CUP10-00059 & CVA10-00032 / Persimmon II, LLC

Planning Division Staff Report

File Number	CUP10-00059 & CVA10-00032
Applicant	Persimmon II, LLC / Rudy Kadlub
Property Address	1511 W. Bannock Street
Public Hearing Date	November 1, 2010
Heard by	Planning and Zoning Commission
Analyst	Susan Riggs
Checked By	Cody Riddle

EXHIBIT 6-10

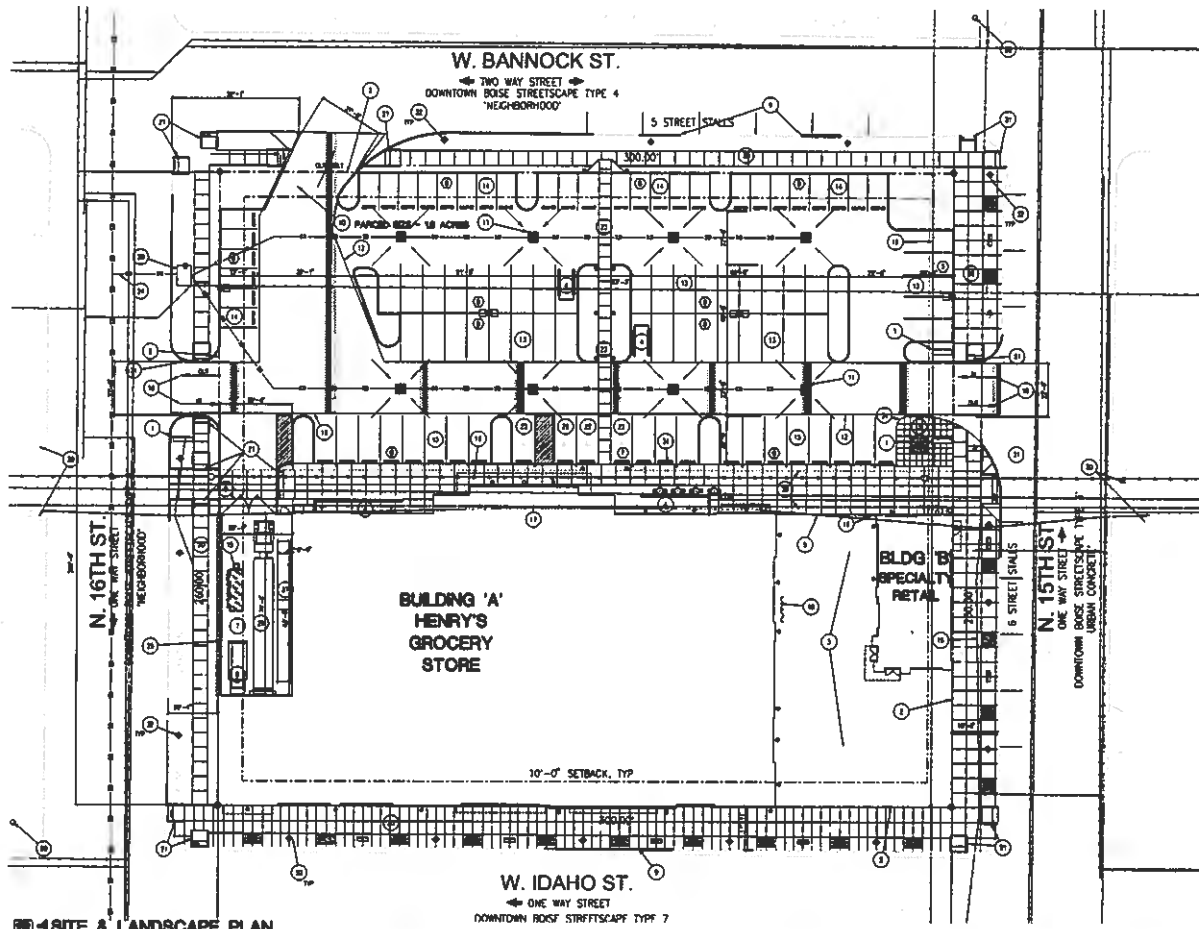
After discussing the need for a continuous bike lane and the alignment concerns with ACHD's Traffic Services, staff recommends the applicant reconstruct Bannock Street with a 46 foot back-of-curb to back-of-curb street section to match the curb line east of 15th Street. This street section will accommodate parking on the north side, two bike lanes and two travel lanes. Between the curb and the right-of-way lines will be a six foot planter with root-barrier, trees, a six foot sidewalk, and space for a two foot wall. Another option is an eight foot planter with trees and no root-barrier, and a six foot sidewalk. This would leave no separation between the site's parking and the sidewalk.

This proposal removes the five on-street parking stalls abutting the site shown on the submitted site plan. Staff supports bike lanes on Bannock Street over five parking stalls.

The applicant is requesting to construct the parking to the property line along 15th, 16th, and Bannock Street. The applicant has proposed a five foot landscape setback in the right-of-way on 16th Street, a two foot-eight inch planter along Bannock Street and no landscaping along 15th Street. Staff believes some relief to the parking setbacks are justified as the parking is separated from 15 to 20 feet from the street with extended sidewalks and planting strips. A condition of approval requires the parking lot to be screened with a five foot landscape buffer along 15th and 16th street and a two foot high screen wall and/or fencing and landscaping along Bannock Street.

1. Compliance with plans and specifications submitted to and on file in the Planning and Development Services Department dated received September 28, 2010 (applications) and October 14, 2020 (all drawings) except as expressly modified by the Design Review Committee, staff, or the following conditions:
2. **Planning**
 - a) Provide a five foot landscape buffer adjacent to the parking lot on 15th Street, similar to the one on 16th Street.

- b) Provide a two foot tall screen wall and/or fencing and landscaping along Bannock Street to help screen the parking lot from Bannock Street.
- c) Building B shall support a use or uses that activate the plaza such as a restaurant, coffee shop or pedestrian oriented retail intended to support residents and employees in the area.
